LINCOLN CITY/LANCASTER COUNTY PLANNING STAFF REPORT

P.A.S.: Annexation #02004 **DATE:** December 22, 2002
Change of Zone #3362
Preliminary Plat #02012 - Big Thompson Creek

PROPOSAL: ANN#02004 - To annex 46.22 acres.
CZ#3362 - To change the zoning from AG to R-3.
PP#02012 - Creates 158 residential lots and four outlots.

**PRELIMINARY FLAT
GRADING AND DRAINAGE PLAN**

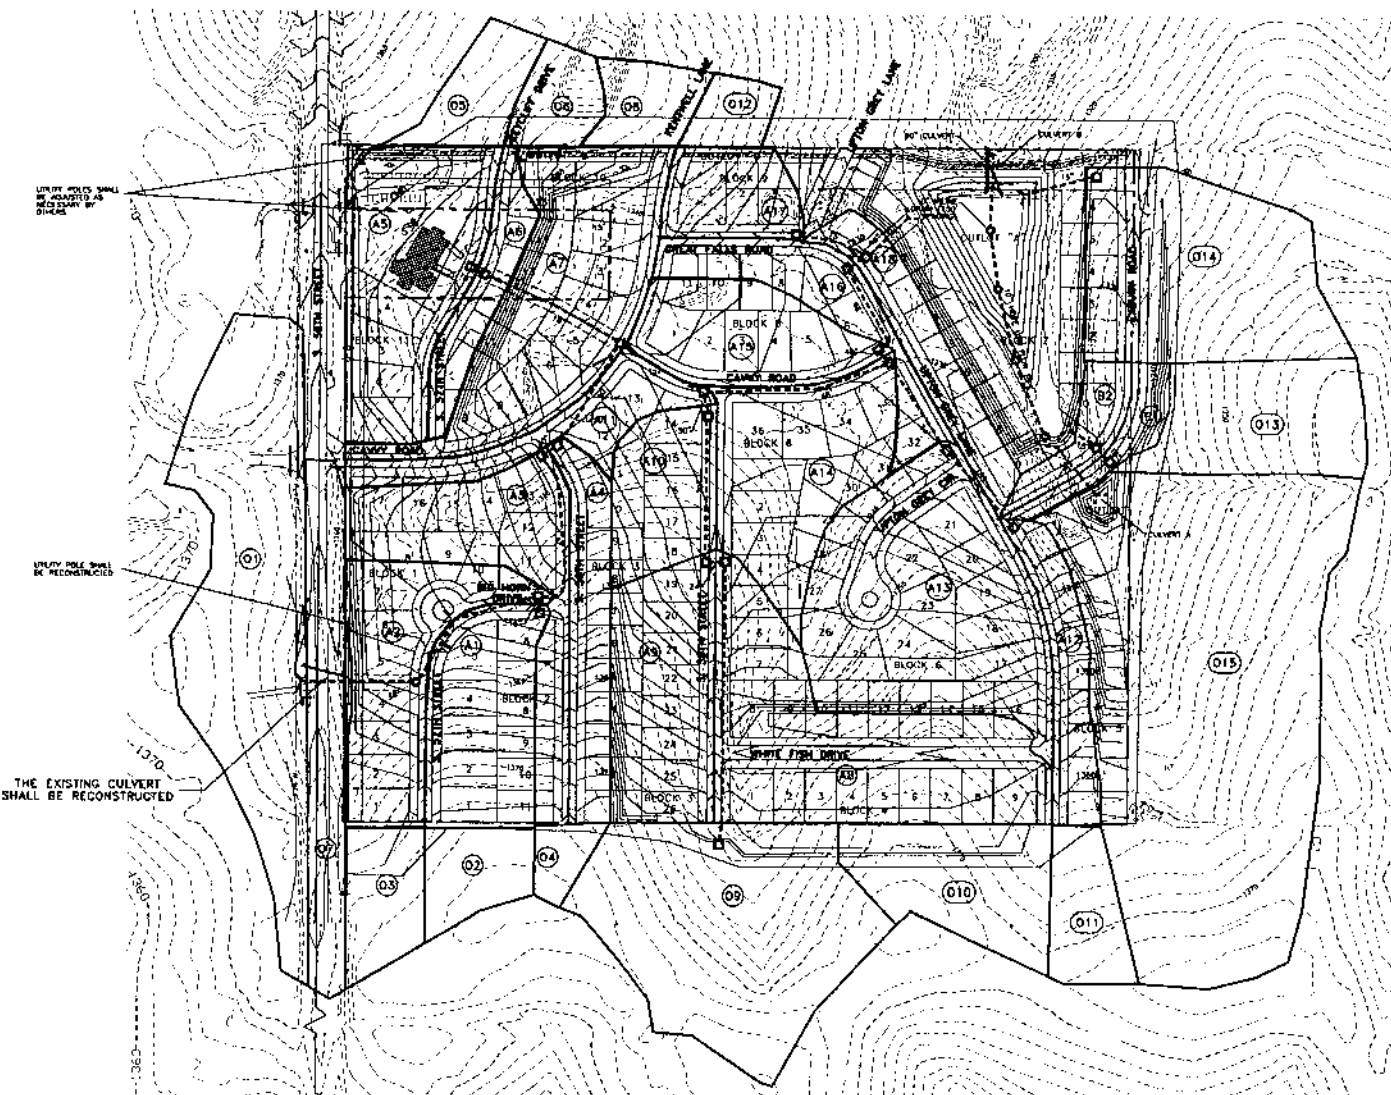
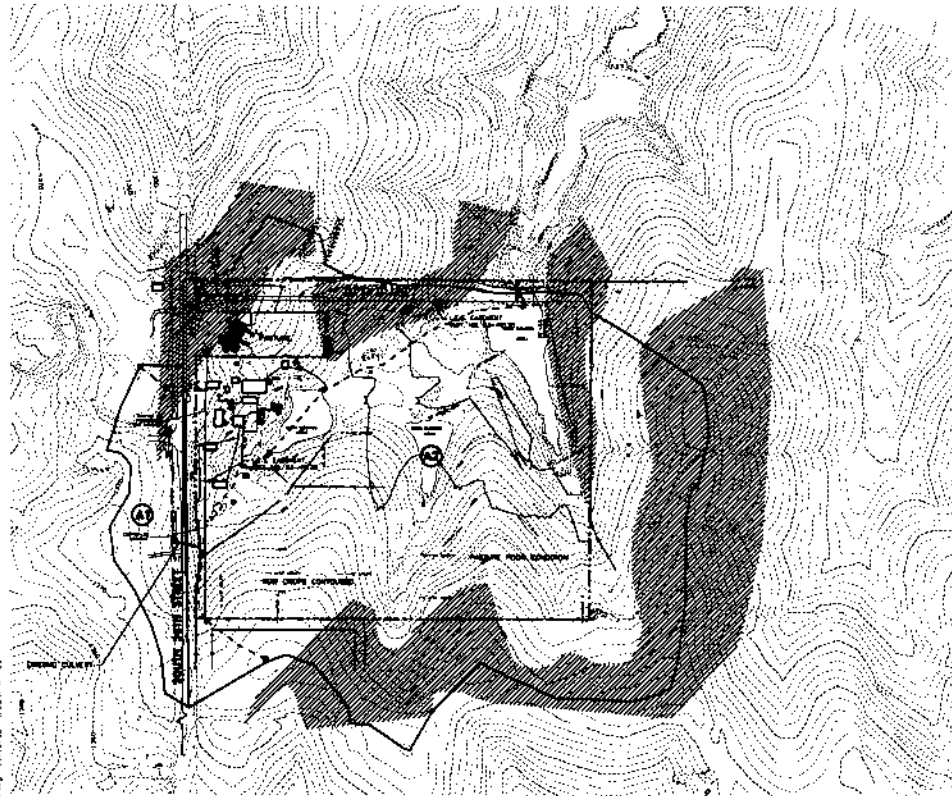
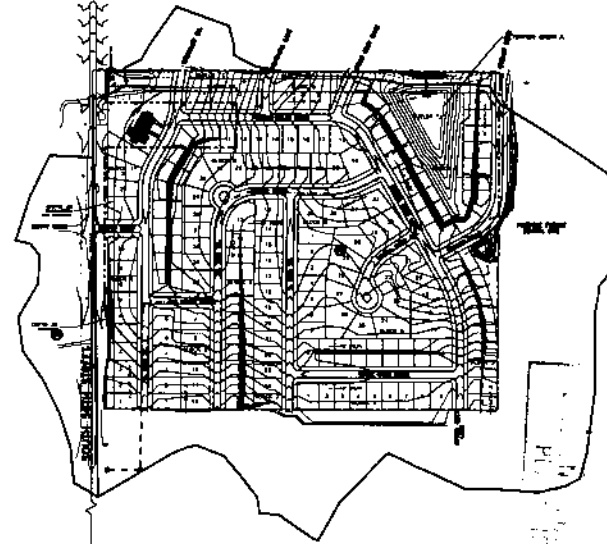
3. Grading/Drainage - As shown, the storm sewer from area A6 does not have the capacity for the 100 yr flood and drainage swale is required between lots 12&13 and 4&5 in block 10. The grading plan should be revised accordingly. Also, provide cross-section and water surface elevation for drainage swale mentioned above and minimum opening elevations for lots 4,5,12, and 13 in block 10.

Provide a cross-section and water surface elevation for the drainage swale between lots 1&2 block 7 and lots 9&10 block 7. Verify minimum opening elevations for lots 1,2,9, and 10 in block 7 according to above water surface elevations.

According to the Thompson Creek development to the north, area O8 should be added to A7 and area O6 should be added to A6.

The grading plan shows grading outside the limits of this plat on the south and east boundaries. Does the developer have permission to grade on these properties?

The slope on the back side of the detention pond dam is greater than the 4:1 maximum. The grading plan should be revised accordingly.

1.2 A revised grading and drainage plan per Public Works and Utilities review.

PRELIMINARY PLAT
LANDSCAPE PLAN

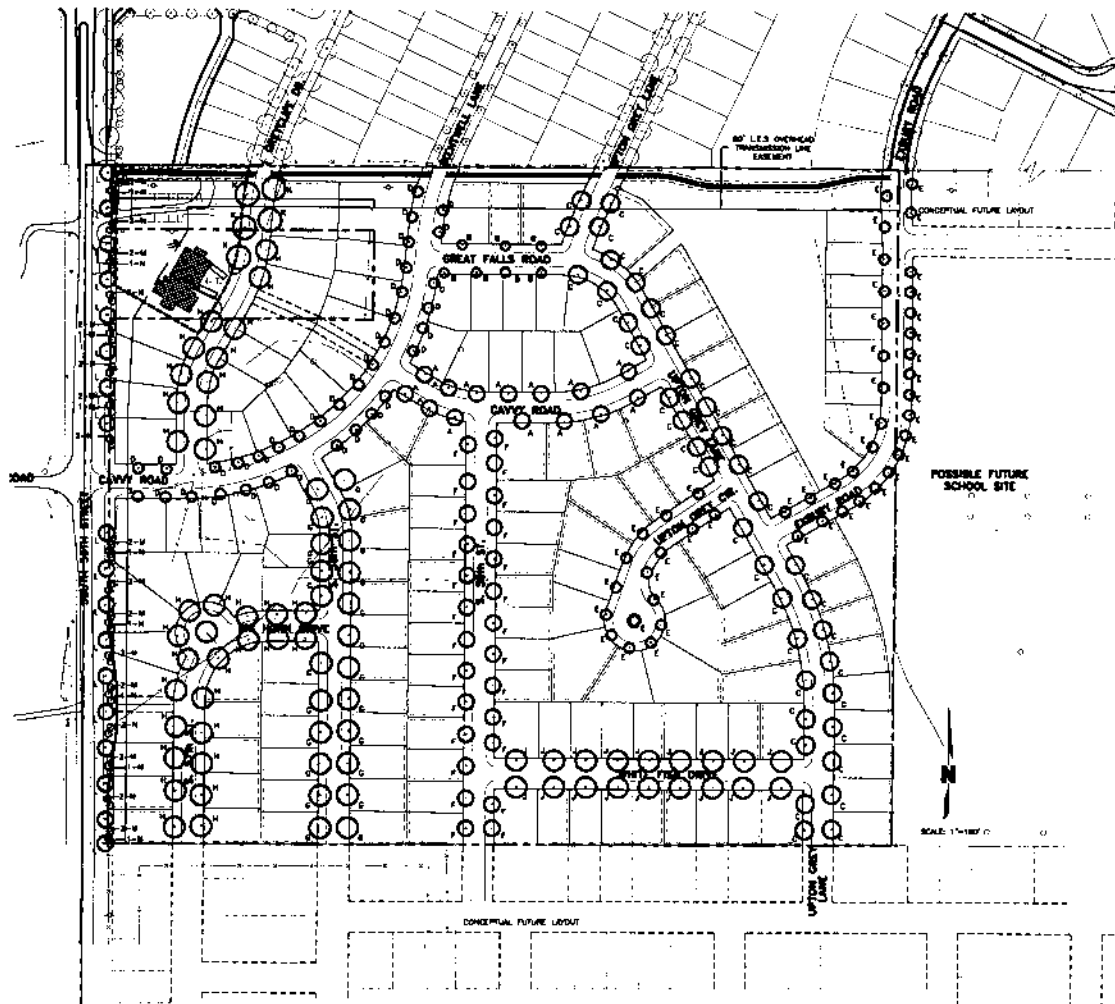
- A. The street trees shown along South 56th Street will interfere with the existing power lines when fully grown. The developer must coordinate an alternate species with the Parks and Recreation Department for planting in this area.
- B. A 20' wide public access easement for the proposed bike trail at the north boundary of the plat.
- C. The intended use for all outlots must be shown on the plat, in addition to being shown in the notes.
- D. All owners of lands within the limits of the plat must be shown.
- E. The required landscape screen along South 56th Street must be located on private property and moved out of the public right-of-way.

- 1.1.3 Required improvements in South 56th Street.
 - 1.1.4 An alternate street tree species approved by the Parks and Recreation Department for planting along South 56th Street.
